PROJECT TITLE: Equipment Installation – Thermal Interconnect	ADD. NO: 1
TENDER NO: 2023-085304T	DATE: October 25, 2023
PAGE 1 of 2 (Including Confirmation Sheet)

Project Name: Canada Games Aquatic Centre  
 Saint John, NB  
 Interconnect from Market Square  
 Installation Package

Title: Additional information for concrete pads, electrical work and clarifications to drawings.
Reason for Change: Clarifications to scope of work.

Drawing Title  
CONCRETE PAD DETAIL

Drawing No.  
**MSK-3**  
REV: 0

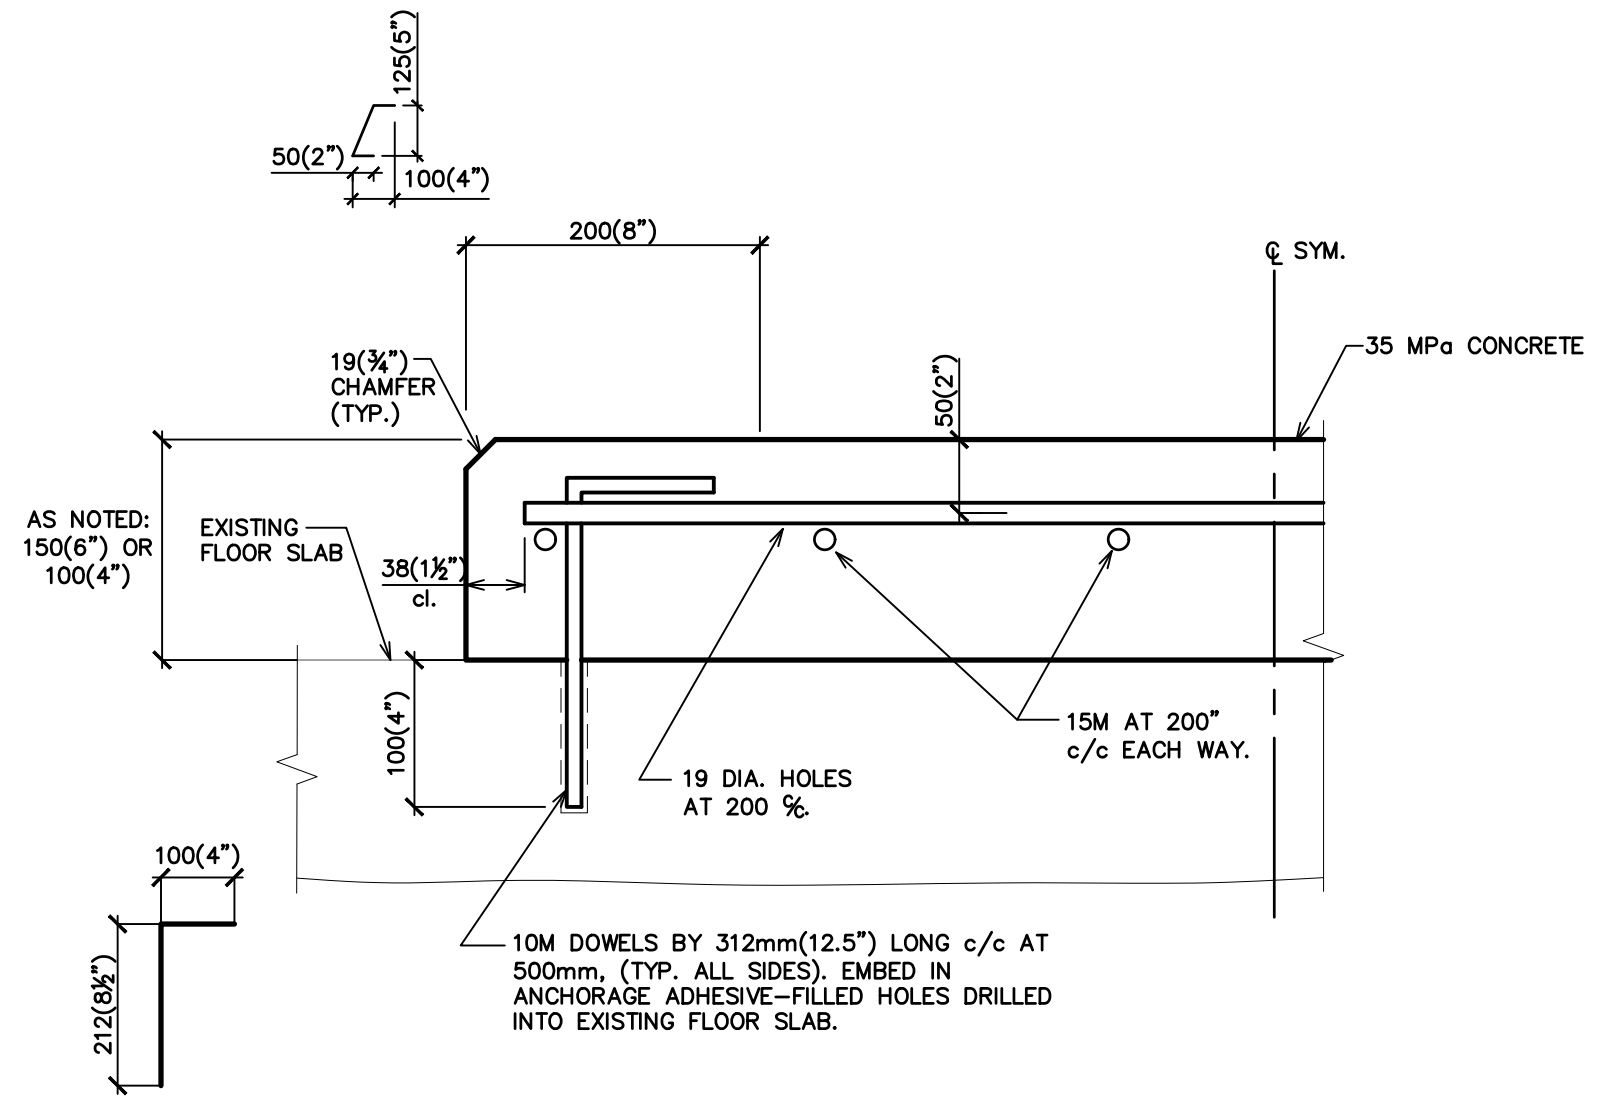
Drawing #	Revisions
M-1 / Grid J-10	<ul style="list-style-type: none"> <li>The heat pump (HTHP-1) is supplied by owner and shall be installed by this contractor. This contractor is responsible for receipt of the heat pump at the Canada Games Aquatic Centre from the delivery truck. This contractor shall carry all costs to move HTHP-1 through the building to its final location in the basement mechanical room and complete installation.</li> </ul>
M-1 & M-2	<ul style="list-style-type: none"> <li>Contractor shall install concrete housekeeping pads for the following equipment. Pads shall be constructed as per detail MSK-3 (enclosed) and per the following dimensions:               <ul style="list-style-type: none"> <li>HTHP size: 4000x2300x150mm</li> <li>HX-2 size: 2300x1800x100mm</li> <li>HX-3 size: 2300x1500x100mm (NEW PAD)</li> <li>CP-1A/CP-1B size: 2000x2000x100mm</li> <li>CP-8A/CP-8B HX-1 size: 4600 (long side to corner) x 2000 x 100mm</li> </ul> </li> </ul>
